# NORTH CAROLINA TURNPIKE AUTHORITY AET STANDARD DRAWINGS

### Typical All-Electronic Tolling (AET) Toll Zone Guidelines

### AET STANDARD DRAWINGS - REVISIONS

SHEET NO. C-3

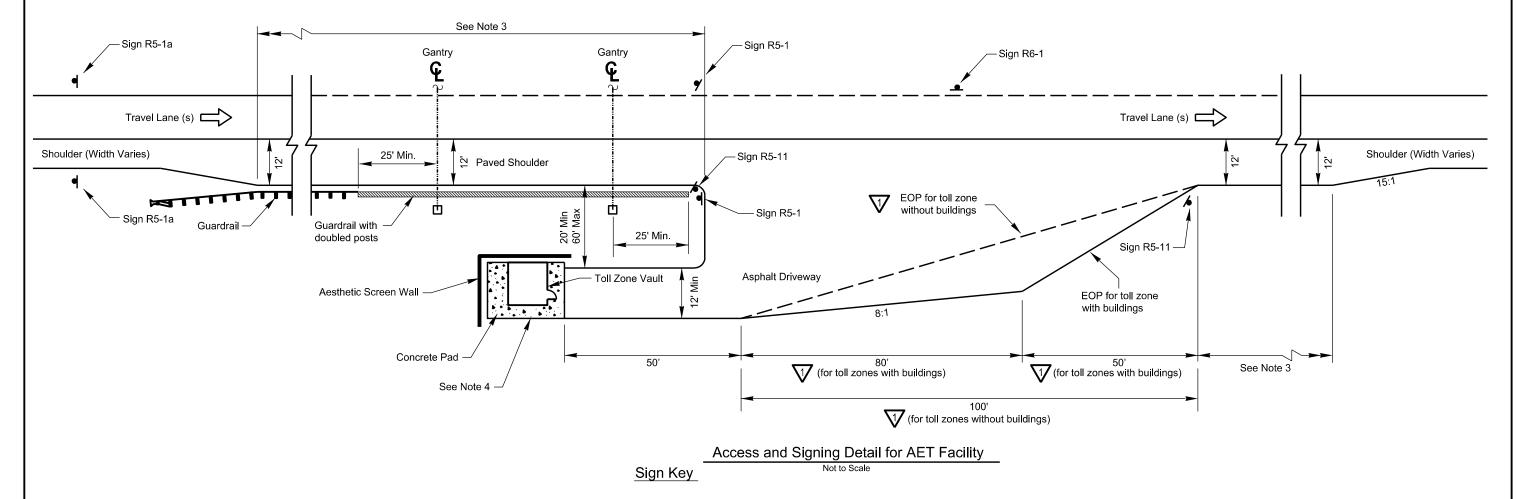
Date	Sheet	Revisions
10/2014	C-1,2,3; A-3	Changed offset of column from 5' min. to 6' min. behind guardrail
10/2014	C-4,5; E-1,2,3	Clarified that barrier thru toll zone shall be double-post guard rail
10/2014	A-1, E-6	Contractor conduit may enter vault thru walls as well as floor
10/2014	A-1	Changed interior long dimension from 15' min. to 11' min.
10/2014	A-2	Added drip cover over door and condensate tubing
10/2014	A-3	Changed nomenclature associated with cable tray
10/2014	E-1,2,3	Added note regarding drains for loop boxes
10/2014	E-4	Added note to provide wire and conduit for grounding
10/2014	E-5	Added note to field-adjust outlets; added note regarding wiring of outside notes
04/2015	C-4	Added details for the smaller driveway for locations without vault
03/2016	A-5,E-7,E-4a	Added new sheets for typical Express Lanes toll zones/sites
